Central Kitsap Fire and Rescue
Station 45

Bid No. 2022-STA45BUILD-50-01

ADDENDUM # 1
April 20, 2022

FLOOR PLAN - LEVEL 1 - POWER

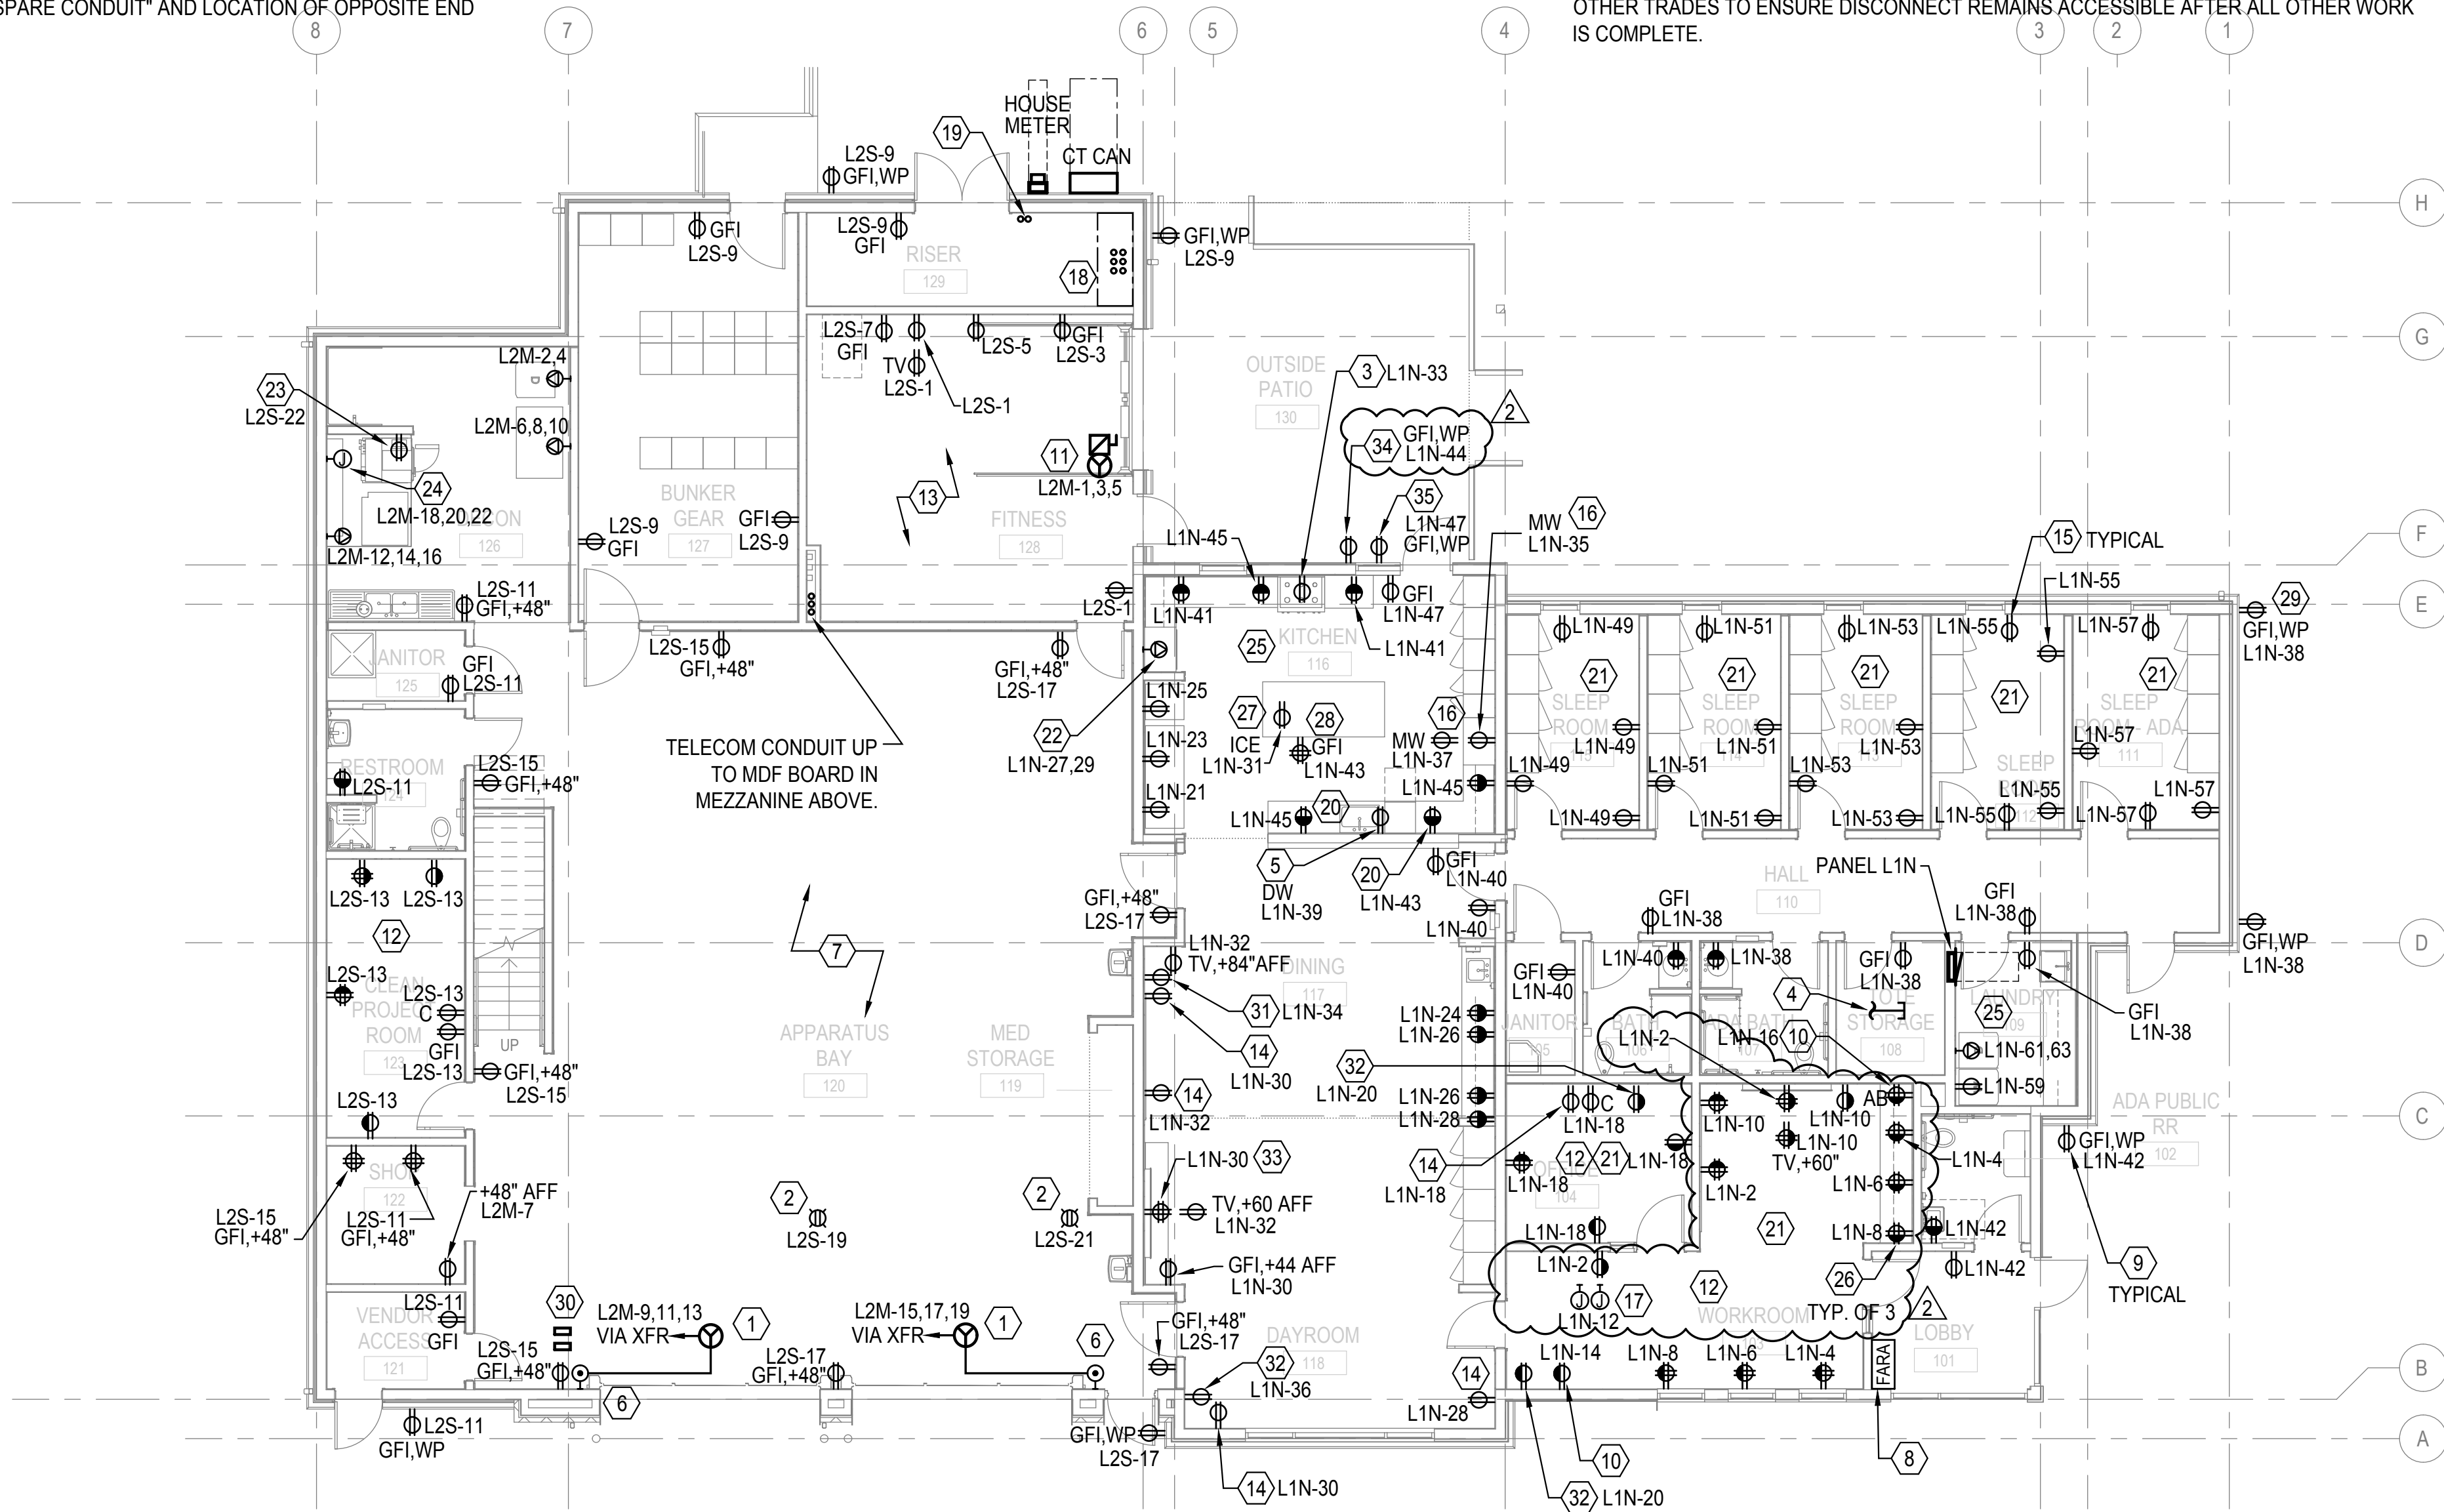
- i. Added GFI, WP callout to BBQ receptacle.
 - ii. Revised circuiting of receptacles at Work Room 103.
 - iii. Revised Flag note #15 to be clearer in intention.

FLOOR PLAN - LEVEL 2 - POWER
SCALE: 1/4"=1'-0"

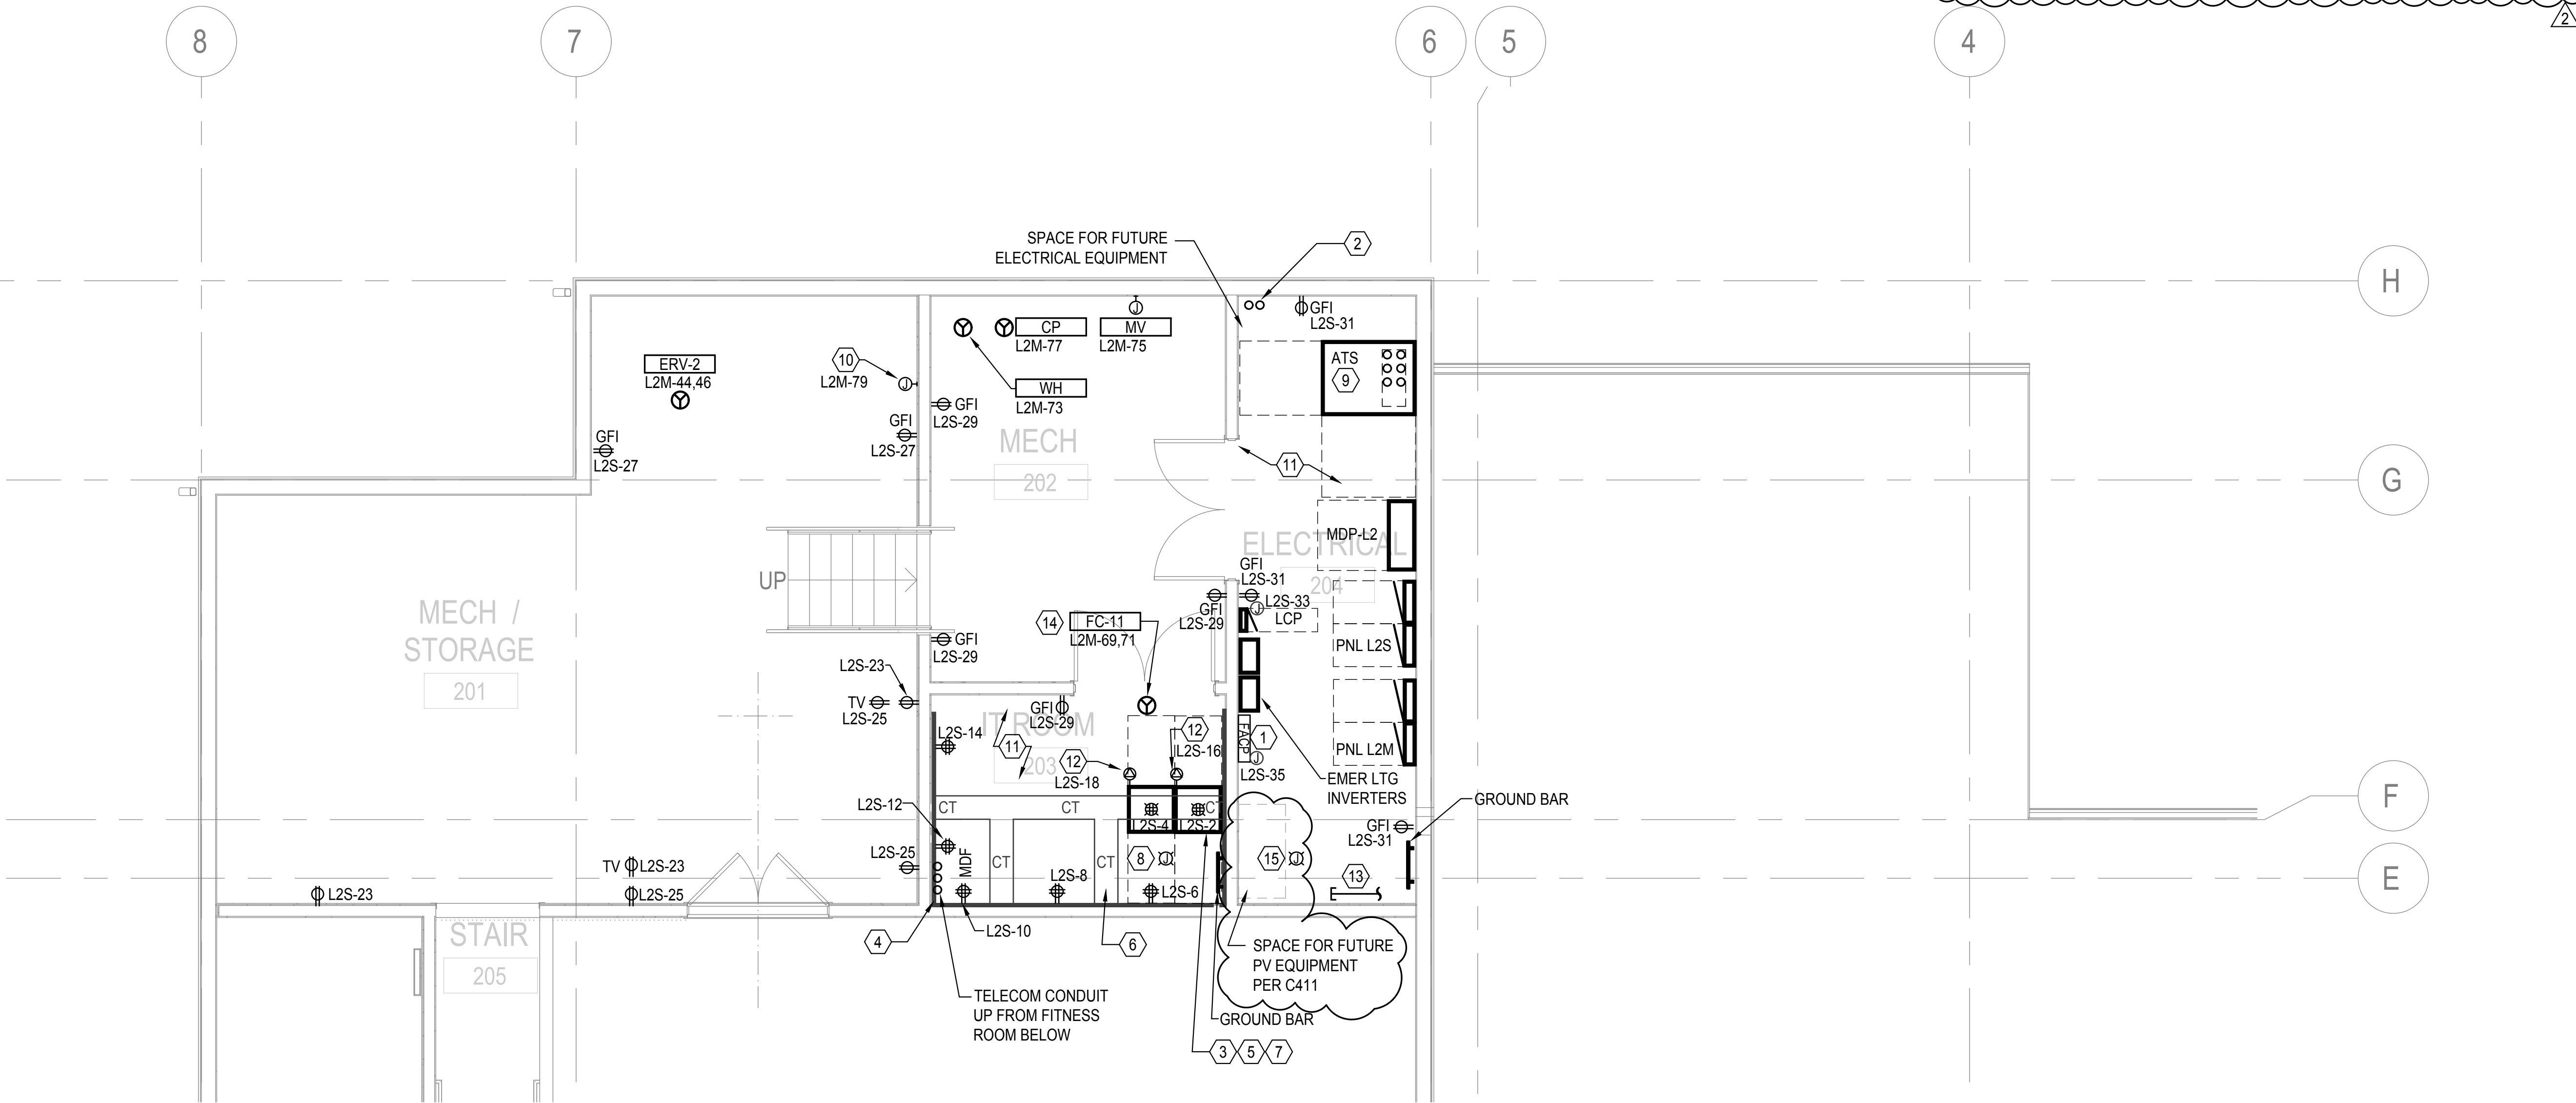
- ITEM 4. DRAWING E22.02
 - a. REPLACE SHEET
 - i. Added callout for area provided for future PV inverters per Energy Code.
 - ii. Located conduit for future PV.

ROOF PLAN - POWER
SCALE: 1/8"=1'-0"

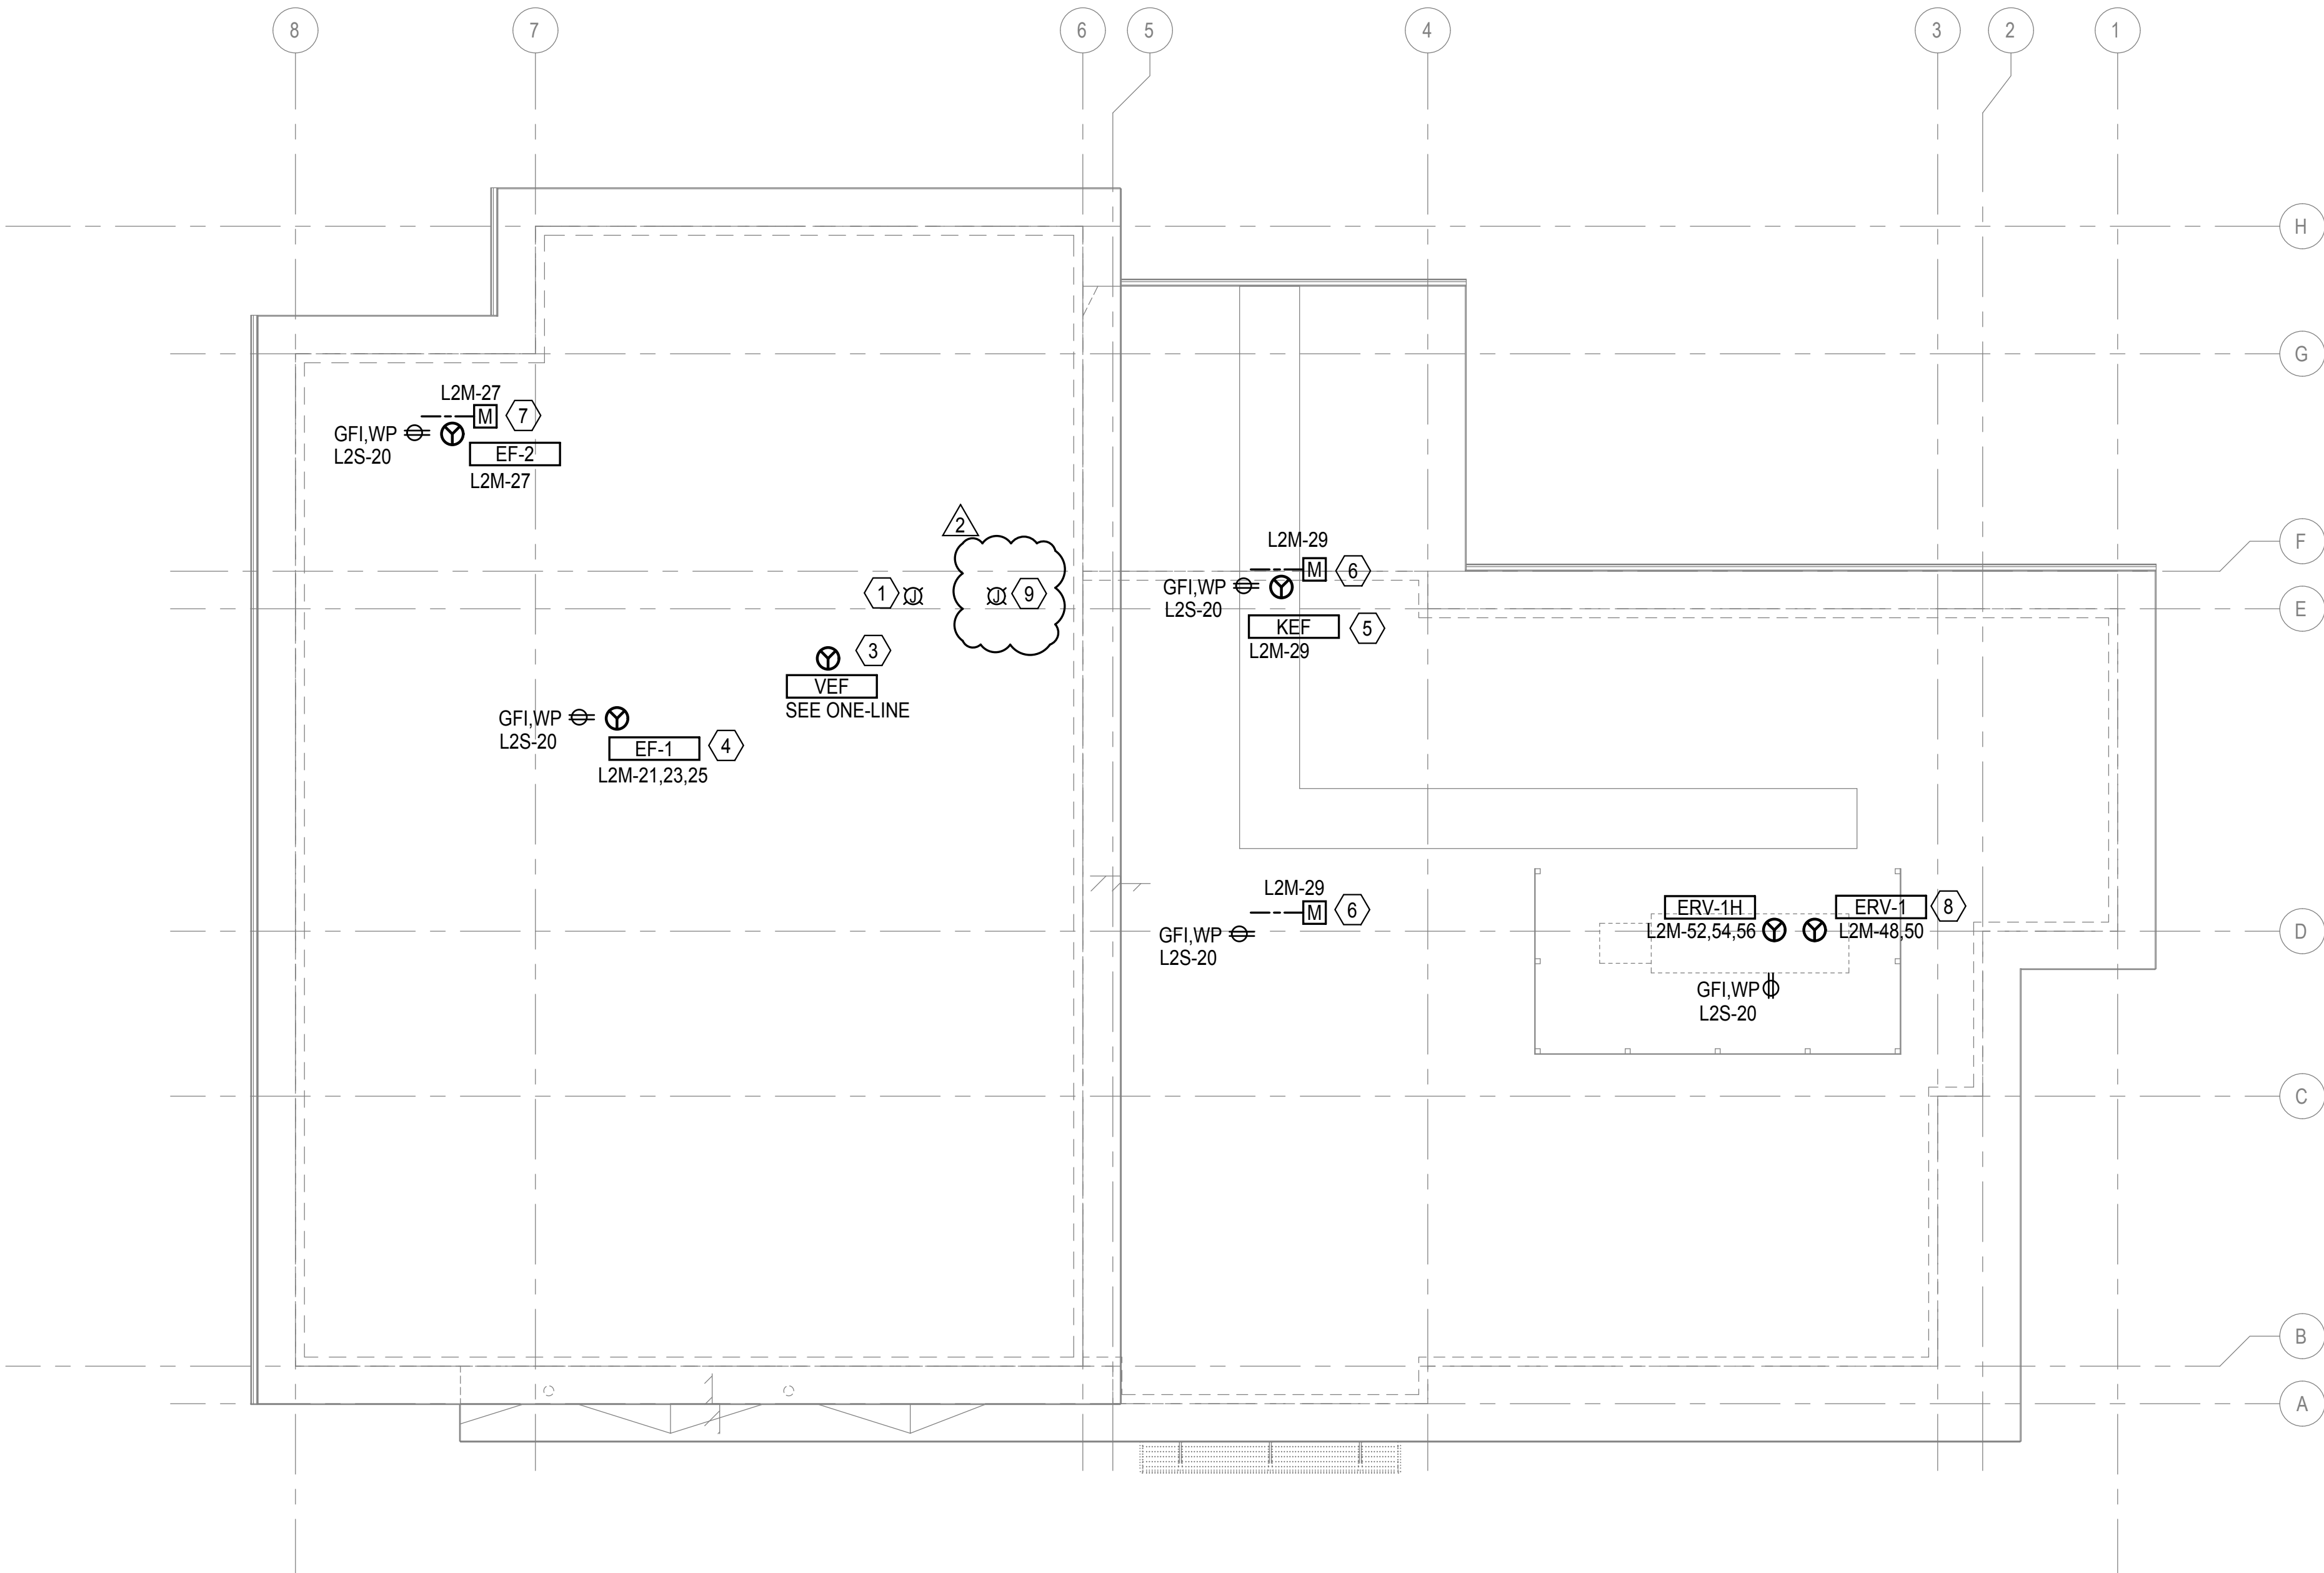
- ITEM 5. DRAWING E22.03
 - a. REPLACE SHEET: Located conduit for future PV.
- ITEM 6. DRAWING E30.01
 - a. REPLACE SHEET: Corrected description for Fixture Type W1 – cylinder specified is direct only.
